5. TSO reflections

Concerns / points raised by Swedenergy & Finnish Energy

Market in SE1

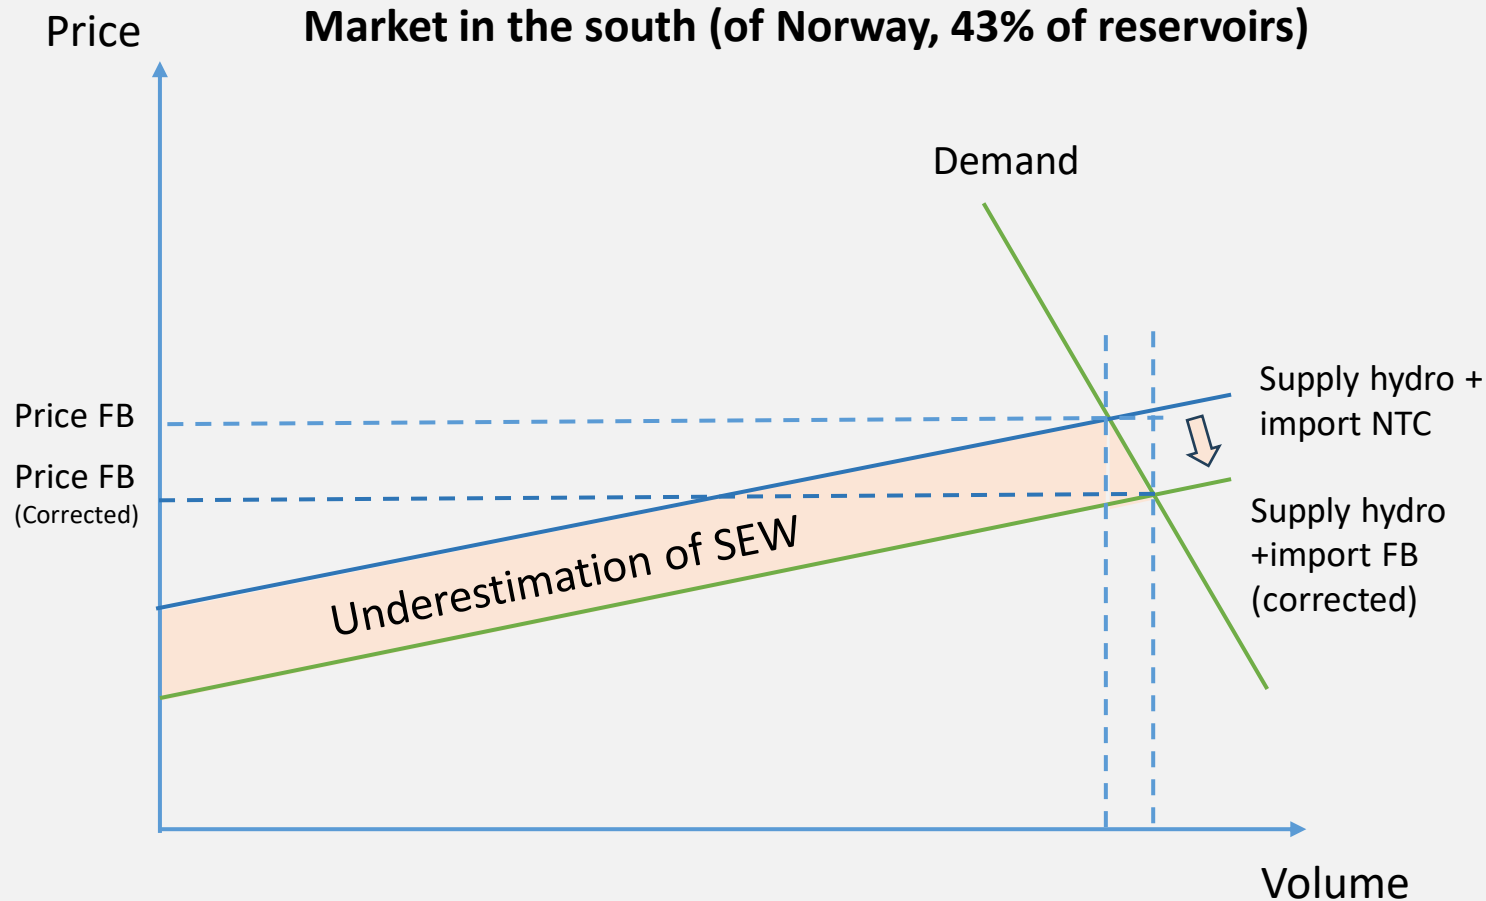
- The diagram illustrates the generic market impact in SE1 in one hour from applying FB parameters in //run
- FB increases the domain and as SE1 is a low-price BZ this will entail increased export as illustrated by the demand curves
- The increased export is done by hydro producers and the grey area illustrates the additional turnover, which is the one that is computed by Energiföretagen.

- **The grey area is not a welfare economic computation**

1. FB simulations overestimates the SEW of FB Reservoir fillings in NTC & FB

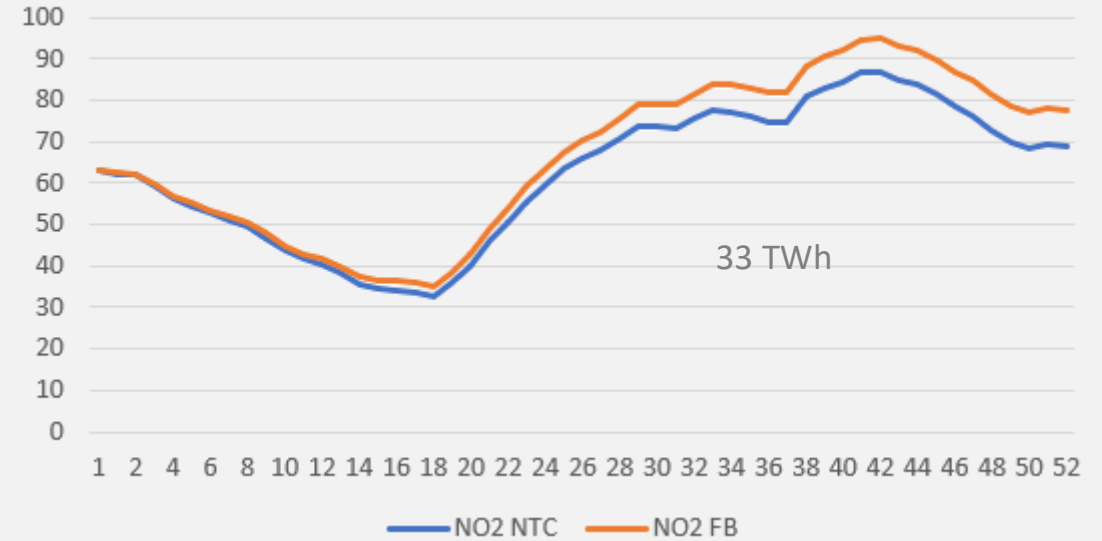
More water used in FB	Less water used in FB	Unchanged
SE1, (SE2), NO3, NO4	NO2, NO5	NO1
61 TWh Reservoir	51 TWh Reservoir	6 TWh
52% of reservoirs	43% of reservoirs	5% of reservoirs
